FIGURE 6.2.1-1
OFFSITE ORGANIZATION8704280671 870421
PDR ADDCK 05000397
P PDR

FIGURE 6.2.2-1a
UNIT ORGANIZATION

FIGURE 6.2.2-1b
UNIT ORGANIZATION — OPERATIONS DEPARTMENT

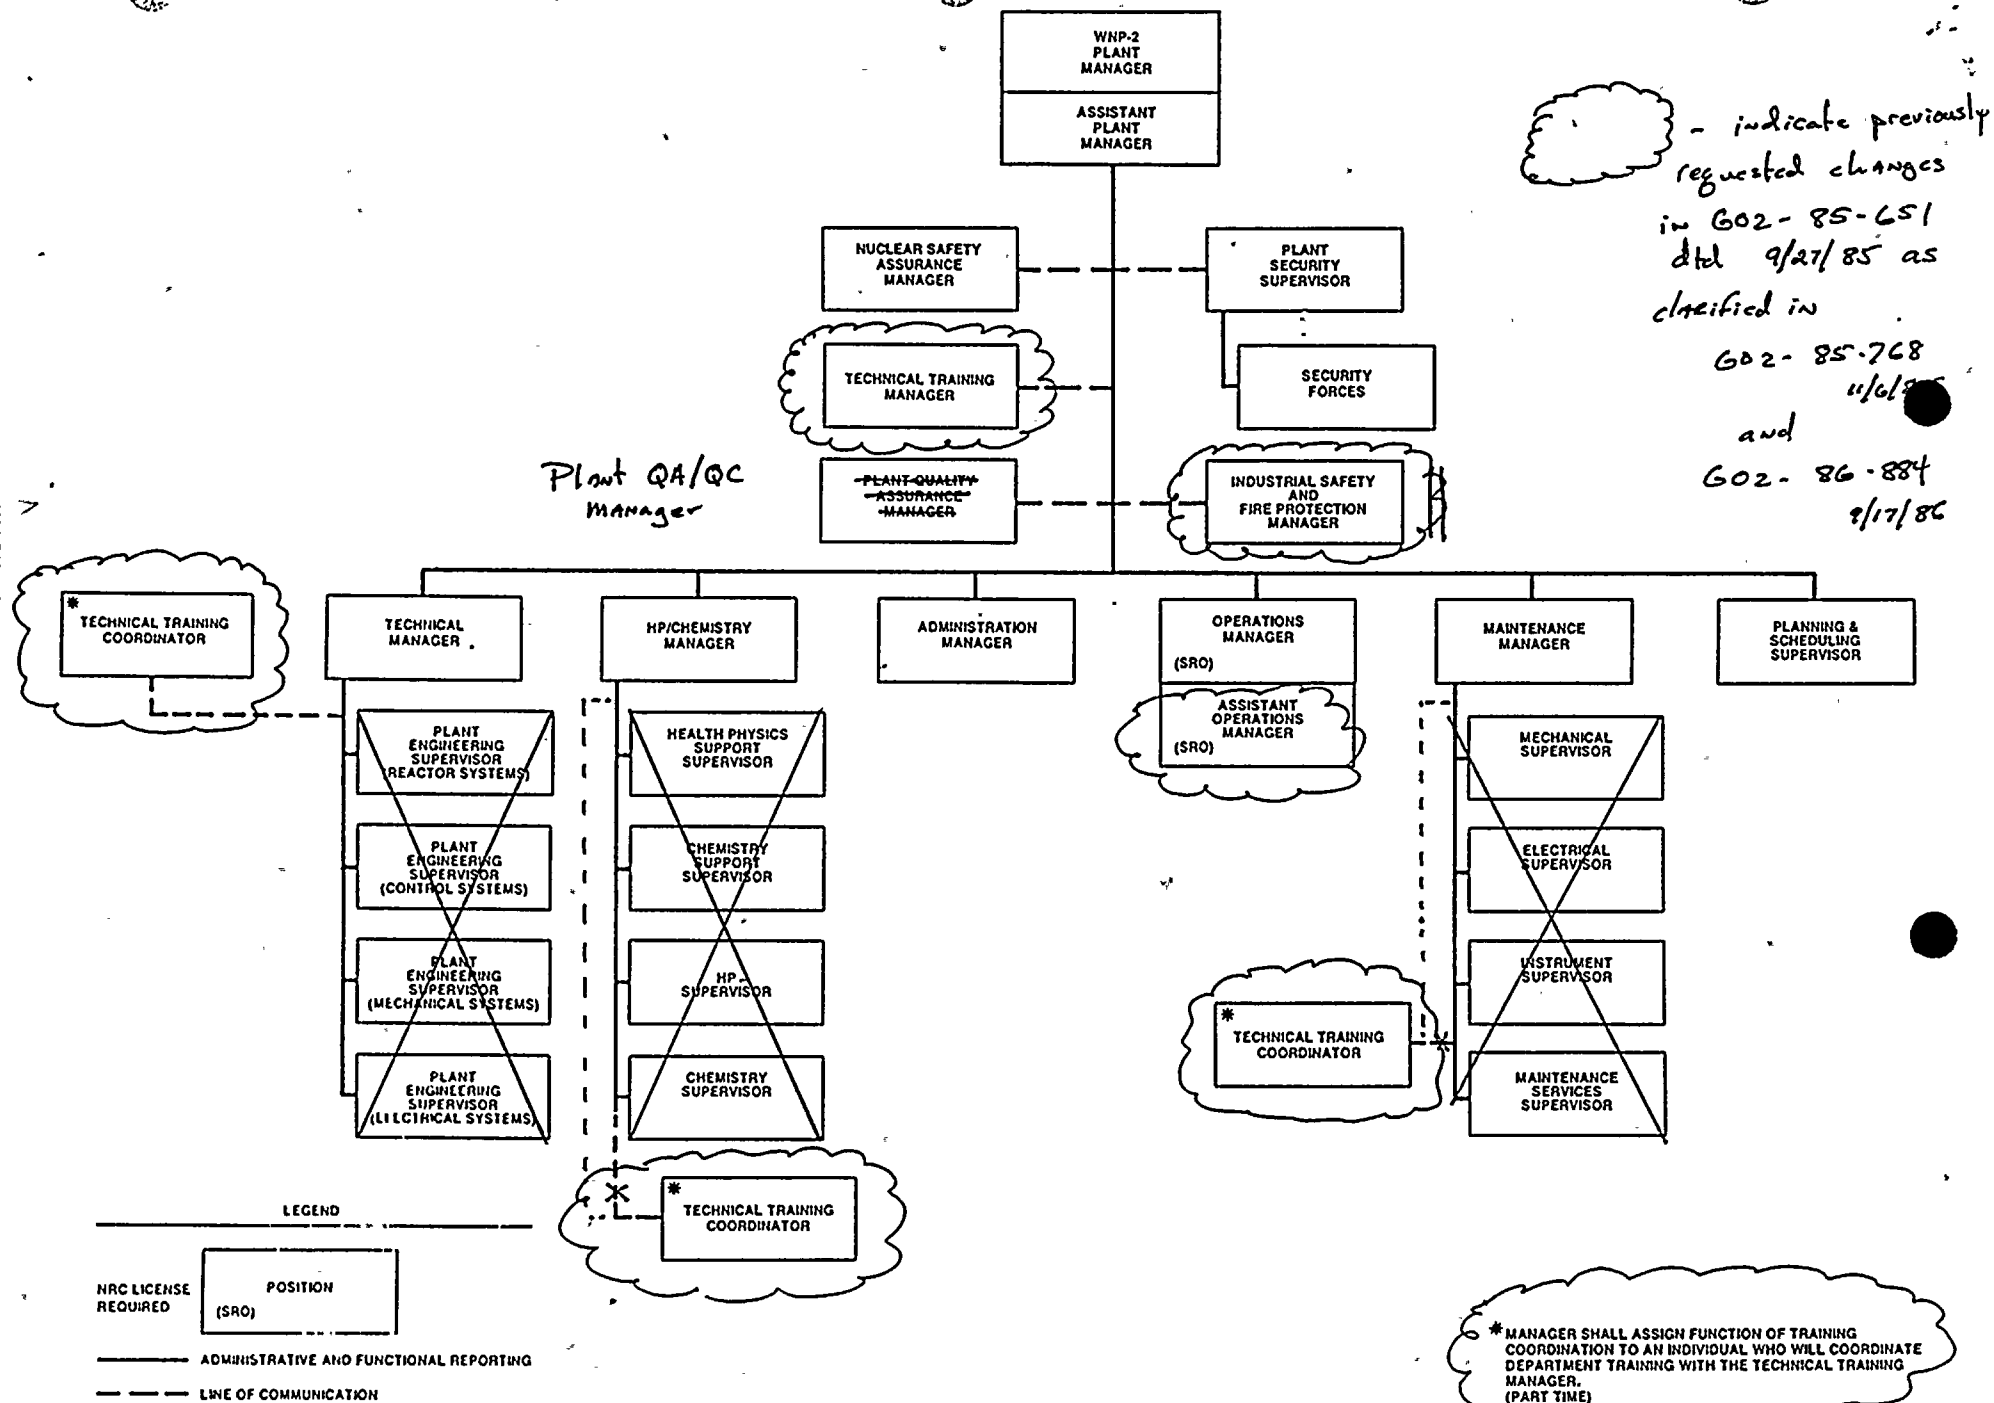
indicates previously requested changes in 602-85-651 dtd 9/27/85 as clarified in 602-85-768 dtd 11/6/85 and 602-86-884 dtd 9/17/86

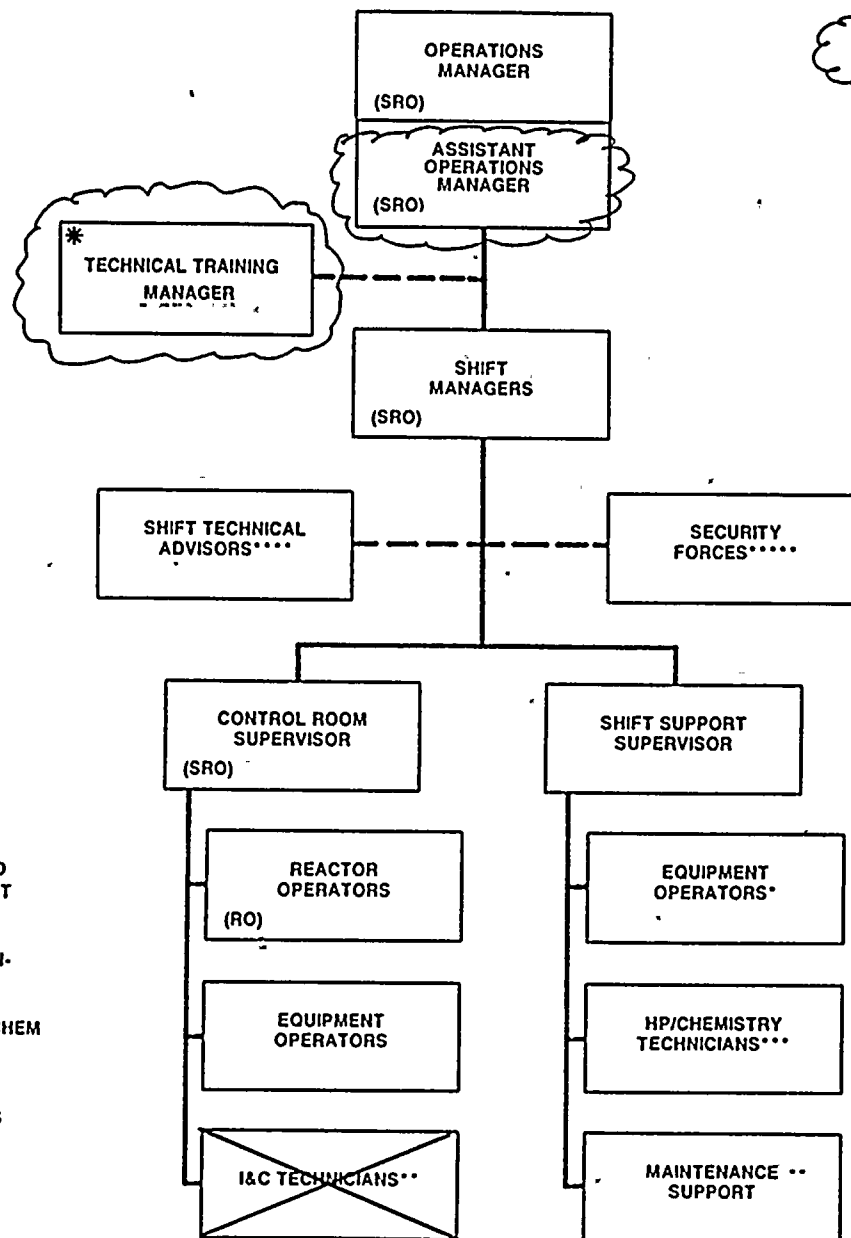
* MANAGER SHALL ASSIGN FUNCTION TRAINING COORDINATION TO AN INDIVIDUAL WHO WILL COORDINATE DEPARTMENT TRAINING WITH THE TECHNICAL TRAINING MANAGER (PART TIME)
